Load Carrying Capacity Modification (Addendum) Label (SET23B)

NHTSA Recall No. 23V757

IMPORTANT SAFETY RECALL

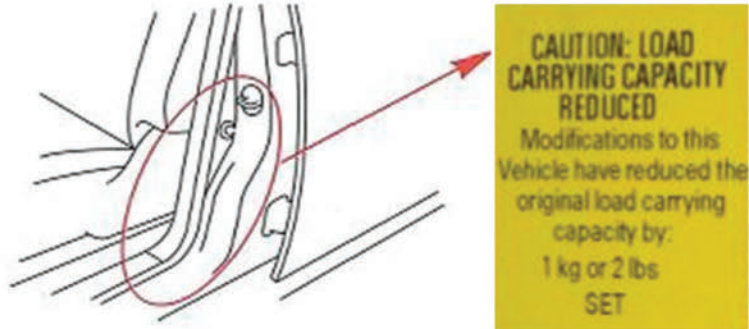
The Addendum Label is a yellow label (see diagram below) located on the driver's side center pillar. The Addendum Label takes into account the net weight of accessories added to your vehicle by SET after it was manufactured and updates the occupant and cargo carrying capacity of your vehicle. The vehicle occupant and load carrying capacity is located on the Tire and Loading Information Label.

In the affected vehicles, the current Addendum Label is not correct. This could result in a driver overloading the vehicle, which may increase the risk of a crash.

Enclosed, you will find a new Addendum Label for your specific vehicle (VIN listed above).

Please assist us by affixing the enclosed Addendum Label to your vehicle. Installation instructions are located on the following page. If you need assistance, your local dealer can affix the label, free of charge.
